**NOVEMBER 20, 2018 ZONING HEARING
"OTHER BUSINESS"
COMMISSION DISTRICT 1**

ITEM OB-062

To consider amending the site plan for Devereux Advanced Behavioral Health-Georgia (Devereux Georgia) regarding application SLUP-1 of 2002, for property located on the southerly side of Stanley Road, and on the north side of Barrett Parkway in Land Lots 242 and 243 of the 20th District (1291 Stanley Road).

DEVEREUX BASEBALL FIELDS
 1291 STANLEY ROAD NW
 KENNESAW, GA 30142
 GRADING & DRAINAGE PLAN
 DISTRICT 20

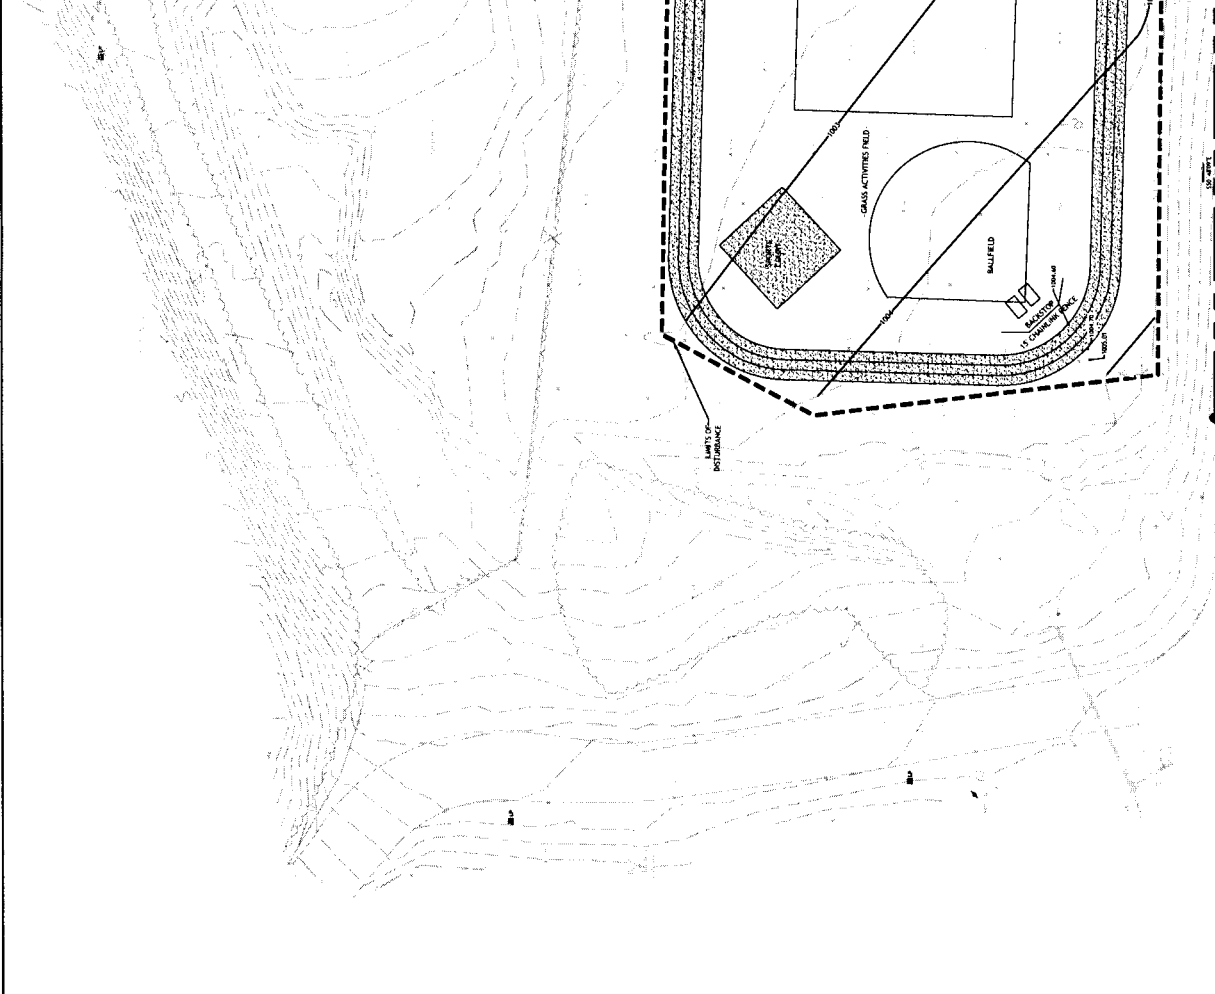
Cobb DOT: Recommend the School Staff continuously monitor field activities and add any safety netting or device required to protect the county roadway from any flying objects from the play fields if they or the County determine there is an issue.

Stormwater Management: Subject to Plan Review and provision for required stormwater management for proposed impervious coverage.

(6) COTTAGES APPROVED IN SLUP-1
 (4) COTTAGES IN SITE PLAN AMENDMENT

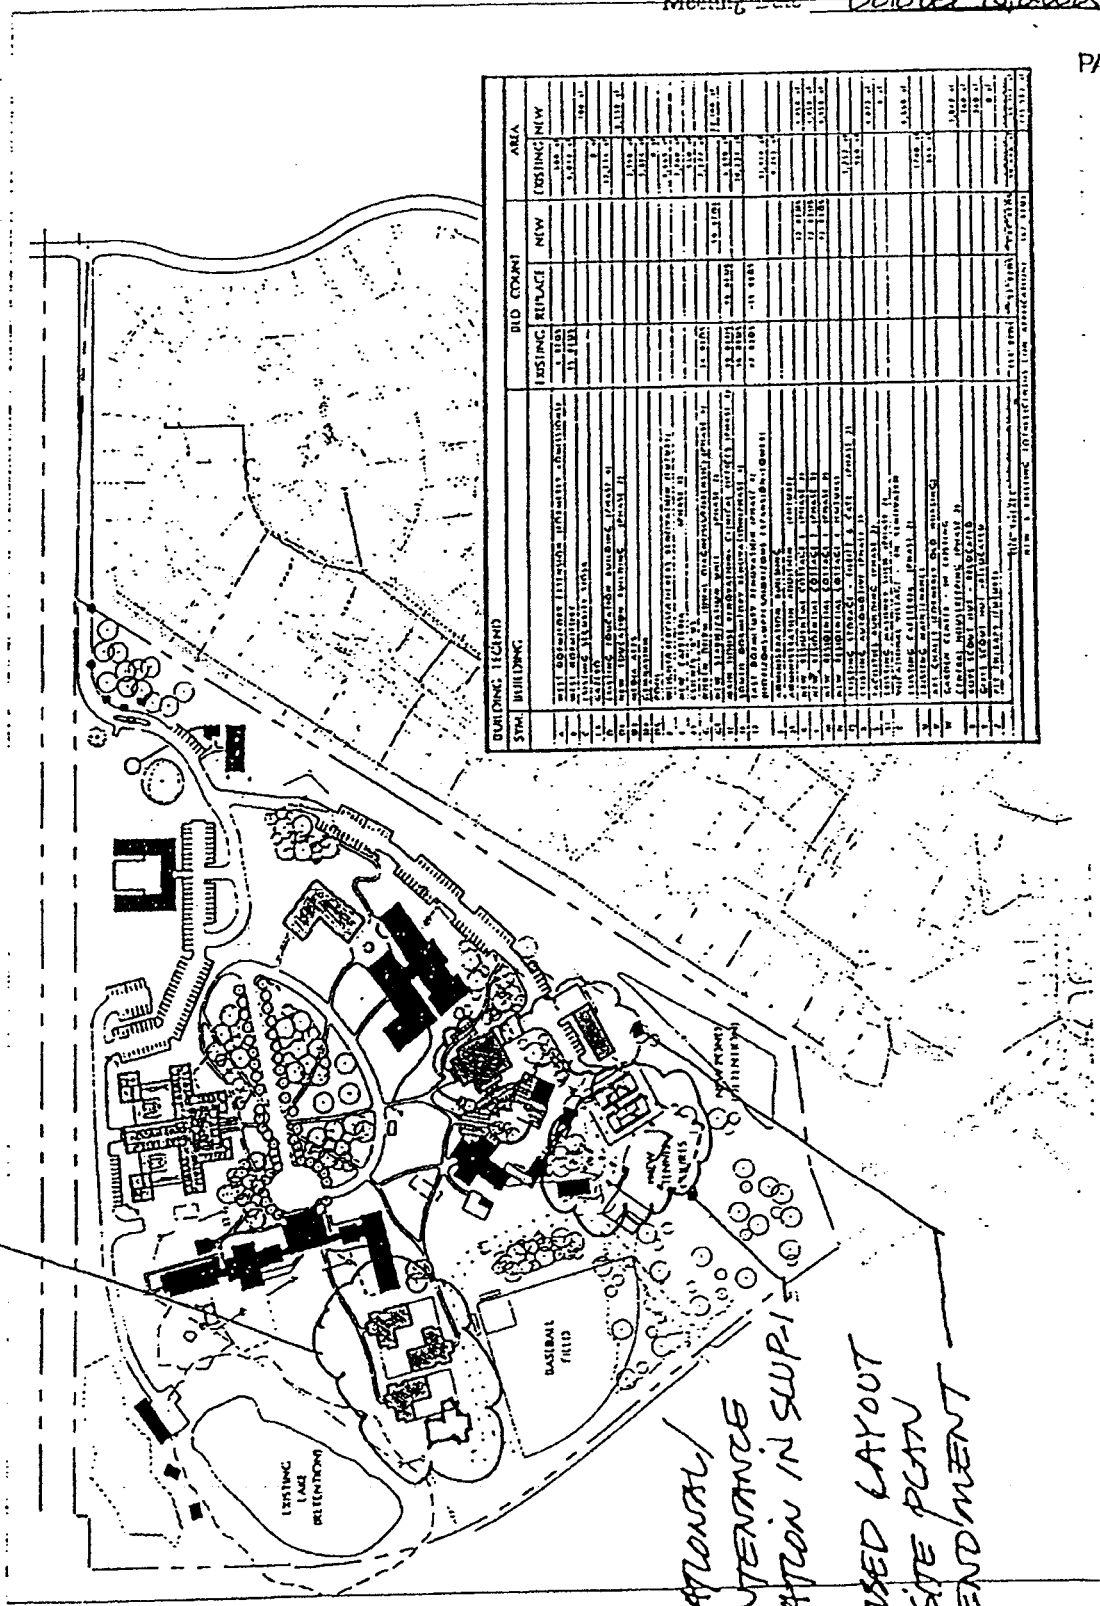
- site plan amendment (copy attached and made a part of these minutes)
- allowance of reduction in the number of residential cottages from six (6) units at 3,200 square feet each to four (4) units at 4,000 square feet each
- all other previously approved conditions and stipulations shall remain in effect

OB# 5
 Min. Bk. 25 Petition No. (SLUP-1 of
 Doc. Type Site Plan 2/19/02)
 depicting fencing
 Meeting Date 10/21/03

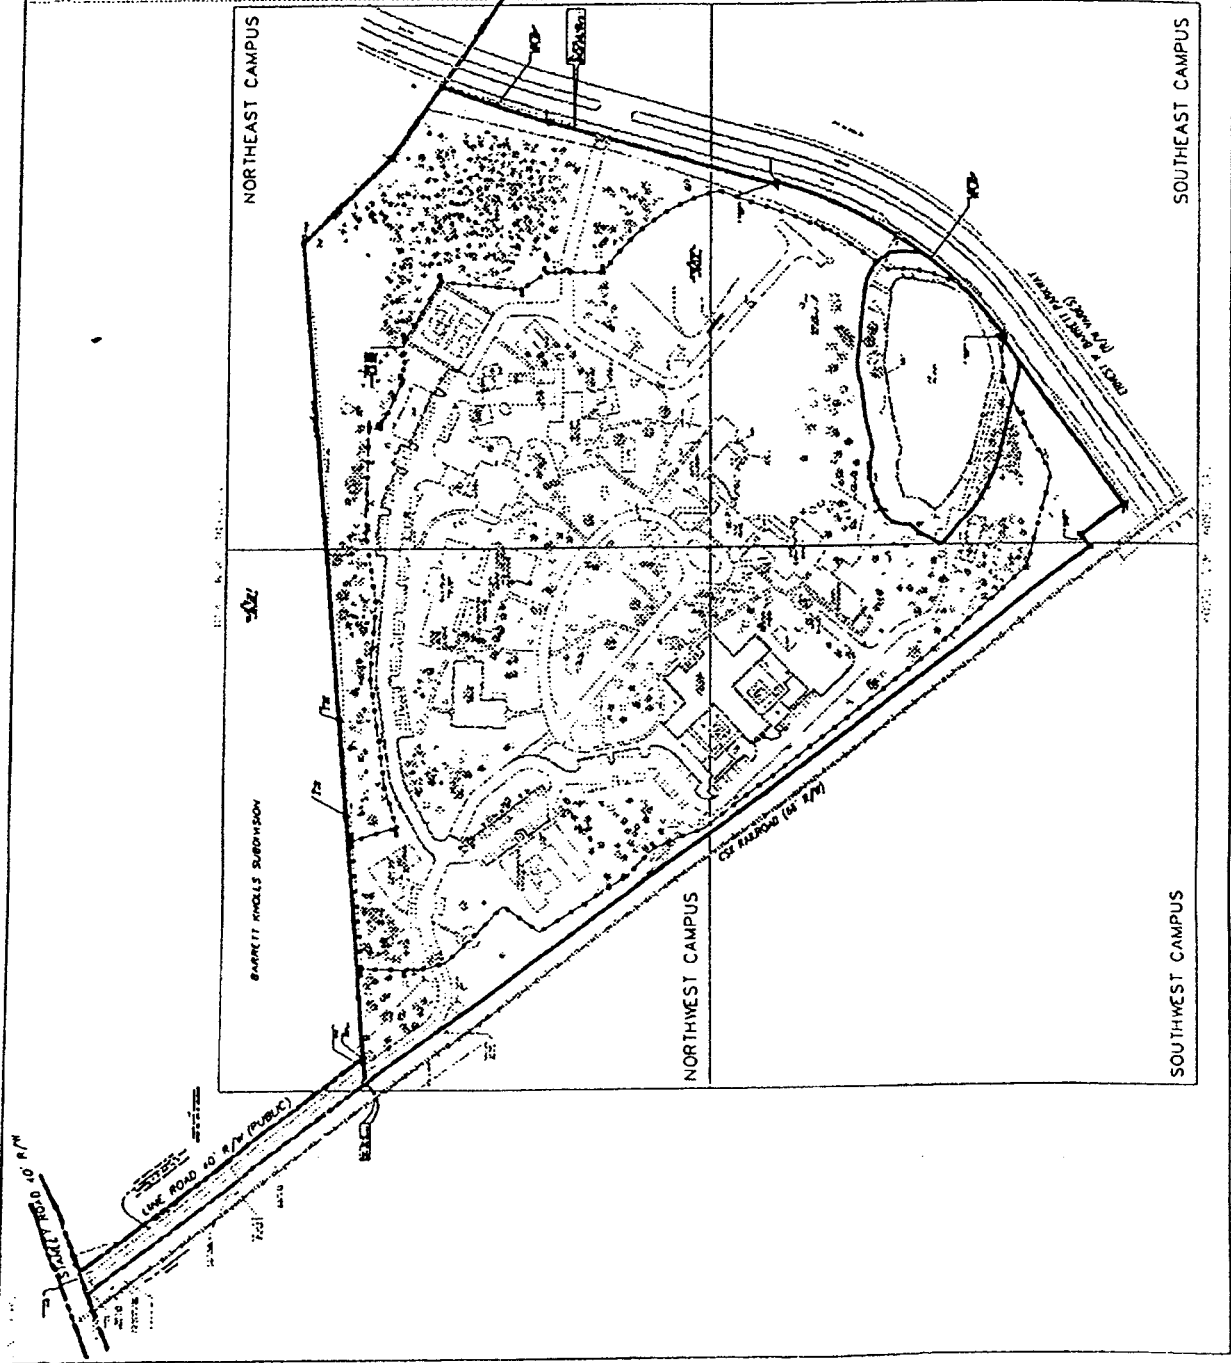
- **site plan received in the Zoning Division on October 14, 2003, depicting twelve (12) foot high fence to be erected around the property (copy attached and made a part of these minutes)**
- **fence details (copy attached and made a part of these minutes)**
- **request letter from Mr. Michael J. Stieferman dated October 14, 2003 (copy attached and made a part of these minutes)**
- **all previously approved conditions/stipulations to remain in full force and effect**
